URBAN DESIGN COMMISSION

DESIGN REVIEW RECOMMENDATION

494 Medford St.

February 23, 2021

Revised Option

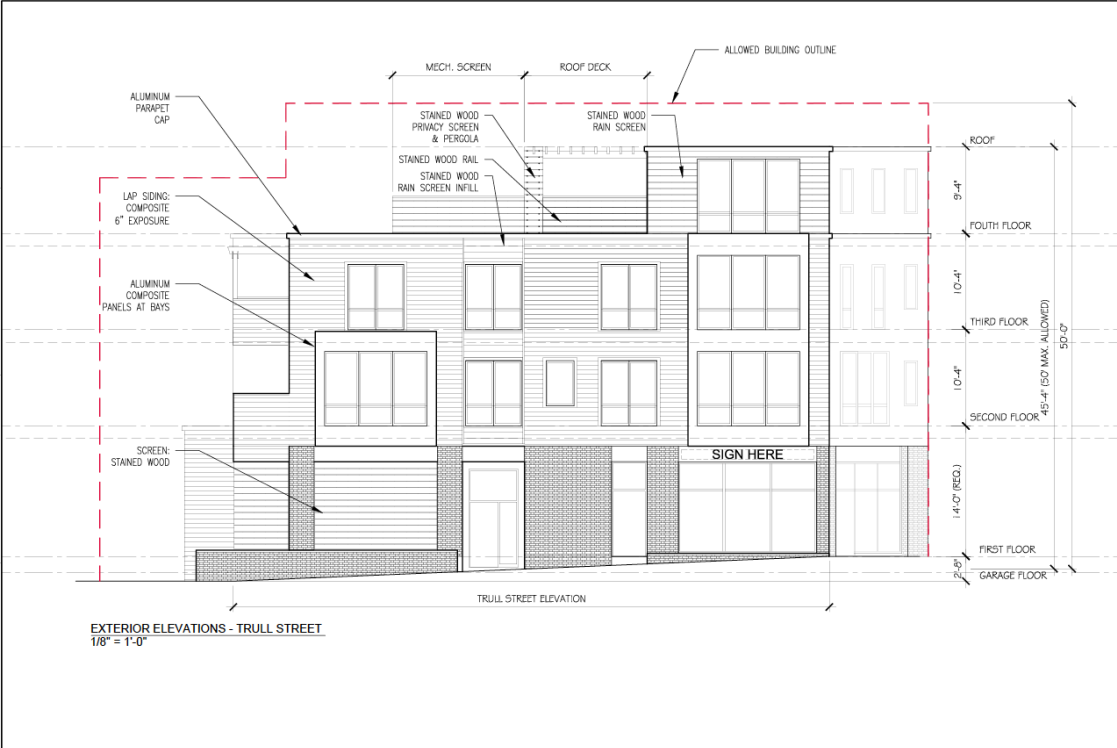
Following a presentation by the Applicant and review of the submitted materials and the design guidelines for the MR4 district, the Commission voted unanimously (3-0) to recommend façade design option #4 for further design development. The Commission advised the Applicant to revise option #4 to have a more well-defined base of the building, with particular attention paid to the ground level columns/piers and the design of the storefront, and for the materials for the balconies to be more contemporary in nature. The Commission requested additional building elevations & massing diagrams and asked the applicant to incorporate the design feedback provided into an updated concept, voting unanimously (3-0) to continue the meeting. On November 23, the Commission reviewed an updated design and voted unanimously (3-0) that the applicable design guidelines were satisfied and to recommend the modified option #4 incorporating the Commission's feedback from the first meeting.

The Commission has remaining concerns over the success of the northern facing frontage area planters at the front of the building due to limited direct sunlight and recommends that the frontage area planters along Trull be expanded in depth to provide proper volume for healthy plant growth. The Commission also identified that the proposal was currently non-compliant to the requirements for expanded sidewalk width but determined that the above issues could be resolved by the Applicant prior to applying for site plan approval.
